REMARKS

Responsive to the Office Action mailed August 5, 2005, Applicant has studied the Examiner's comments and the cited art. Claims 1, 3-16 and 21-24 are pending prior to entry of this Amendment. Following entry of this Amendment, claims 1, 3-16 and 21-24 are pending. In view of the following remarks, Applicants respectfully submit that the application is in condition for allowance.

Amendments to the Drawings

Fig. 2A

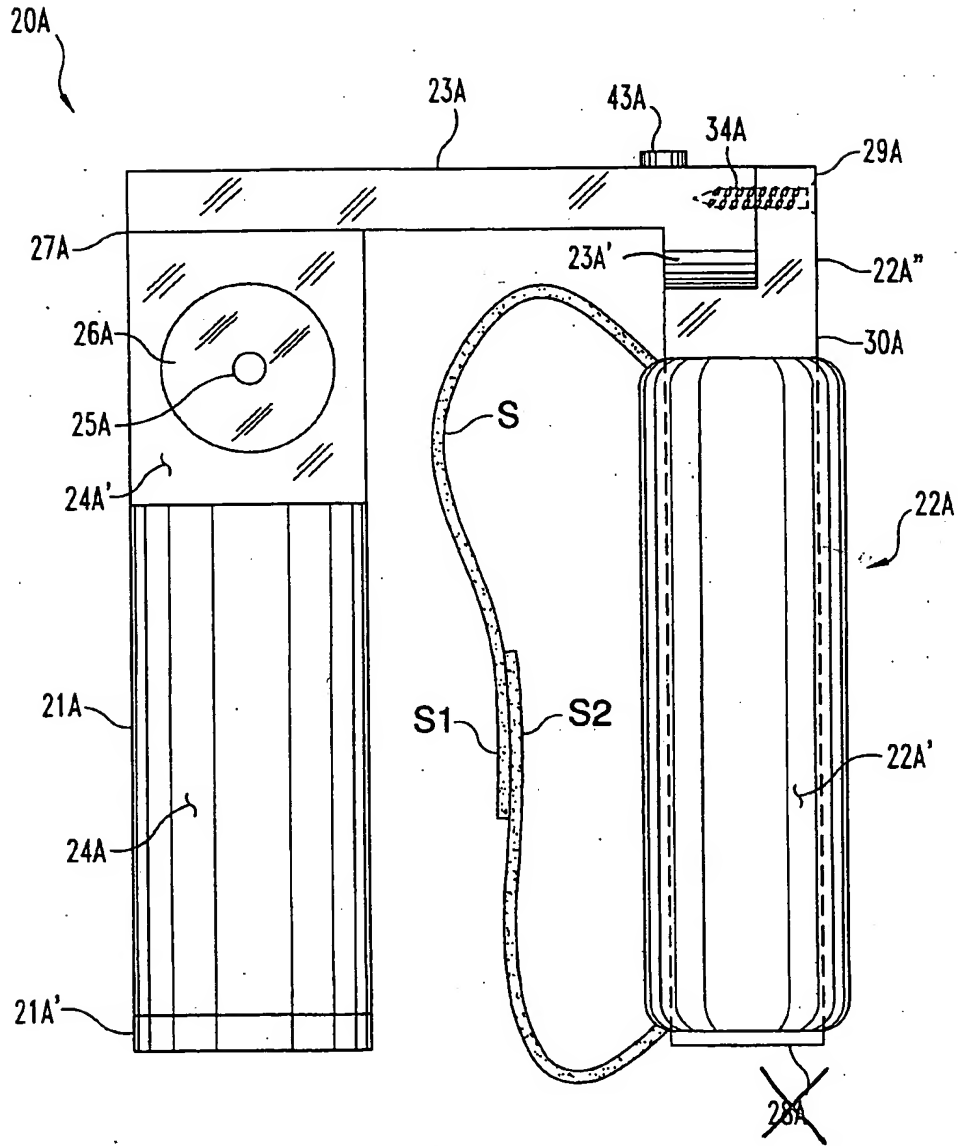
The Examiner indicates that the drawings are objected to as failing to comply with 37 CFR 1.84(p)(5) because they include the following reference characters not mentioned in the description: 28A in Fig. 2B; 88 in Fig. 17; and 96B in Fig. 20.

Applicant submits that there is no 28A in Fig. 2B, although there is a 28A in Fig. 2A. Applicant has amended the drawing to address this objection as discussed below.

Please amend drawing sheet 2 – Fig. 2A. Reference number 28A has been deleted. Applicant submits herewith a marked-up copy labeled as “Annotated Marked-Up Drawing Sheet 2 of 15” and a replacement sheet labeled as “Replacement Sheet 2 of 15.”
